PART 21 INTERIM REPORTING REGARDING TRICENTRIC TRIPLE OFFSET BUTTERFLY VALVES

RE: 10CFR Part 21 Interim Reporting of TRICENTRIC Triple Offset Butterfly Valves

WEIR	10 CFR PART 21 EVALUATION	DOCUMENT	PAGE
	Evaluation of Deviation or Potential Failure to Comply	10 CFR 121813	1 of 4

Figure: Critical Dimensional Characteristics Related to Unseating

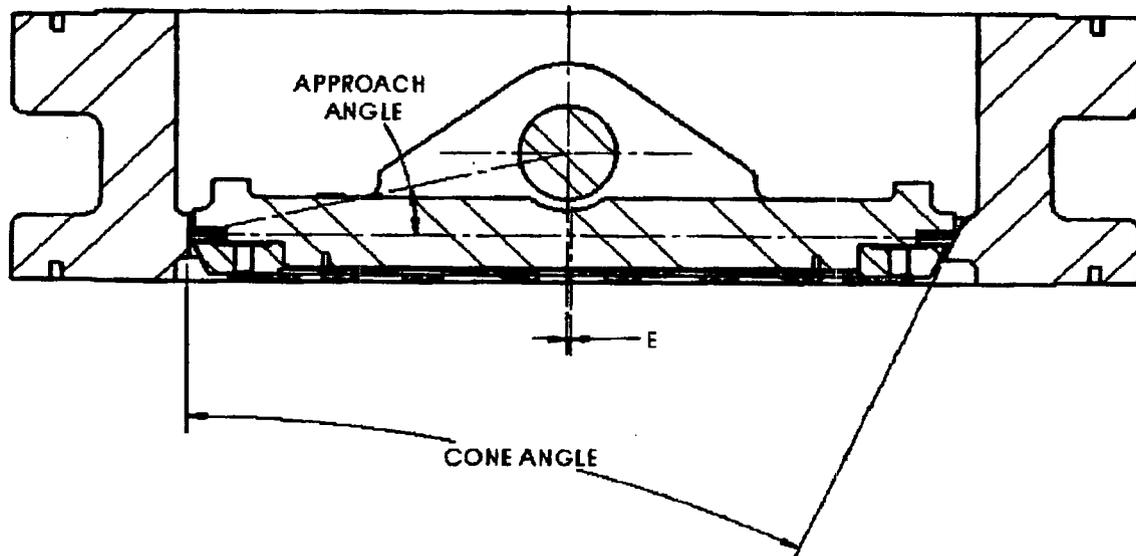
Review 1: Seat versus Unseating Load

Weir has completed a regression analysis of the loads to seat then unseat the valve. The load to unseat the valve with packing and bearing loads removed is proportional to the input torque. Weir reviewed the variables that could contribute to the load. The TRICENTRIC surfaces employ a series of angles to create the seal, it was determined the seal stack on the shaft offset side was the point of drag on the unit. Additionally, Weir established that the torque could be conservatively described by:

$$T_{ULS} = [T_{s@0 \text{ degrees}} * \mu_{fs} * \text{SIN Approach Angle}] / 2$$

Independently T_{Uip} could not exceed $T_{s@0 \text{ degrees}}$ as the approach angle and friction plus the additional normal load to create the seal exist and the sealing load must work on the entire seal perimeter. Therefore, this load will need to be captured and reported in Weir's actuator sizing calculations but does not have an impact on safety.
